<b>Subject:</b> <b>KEY REMINDER CHIME KEEPS CHIMING OR KEYLESS ENTRY INOPERATIVE</b>	<b>Bulletin No:</b> 09-032/06
	<b>Last Issued:</b> 07/21/2006

2004 - 2006 Mazda3 vehicles with VINs lower than JM1 BK\*\*\*\* \*\*526084 (produced before April 18, 2006)

2006 Mazda5 vehicles with VINs lower than JM1 CR\*\*\*\* \*\*125853 (produced before April 18, 2006)

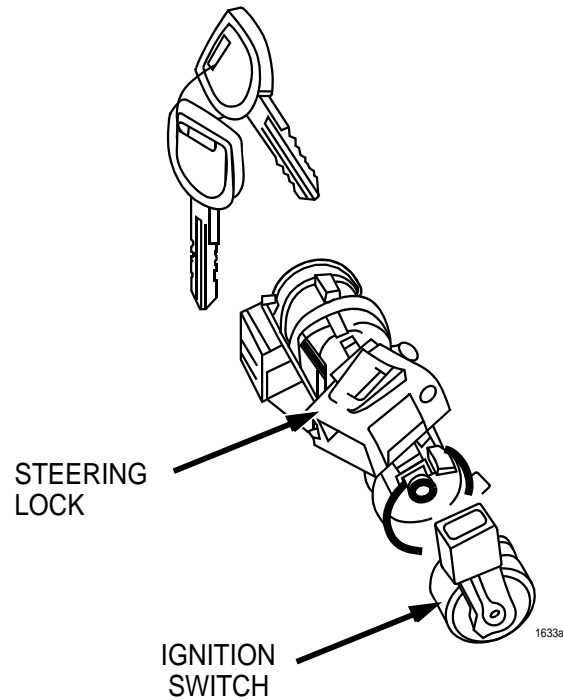
On some vehicles, the key reminder chime keeps chiming even though the key is pulled out of the ignition. In addition, the doors cannot be locked with the keyless entry system. This is caused by an internal failure from a contact plate that was not properly molded.

Customers having this concern should have their vehicle repaired using the following repair procedure.

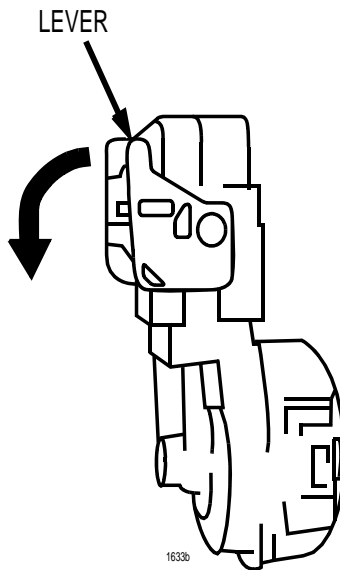
5. Remove the ignition switch from the steering lock.

6. Disconnect the connector from the ignition switch by pulling down on the lever.

7. Reconnect the connector to the new ignition switch.  
8. Install the new ignition switch.  
9. Install the column cover.  
10. Reconnect the negative battery cable.  
11. Verify repair.  
12. Reset the customer's radio station presets.
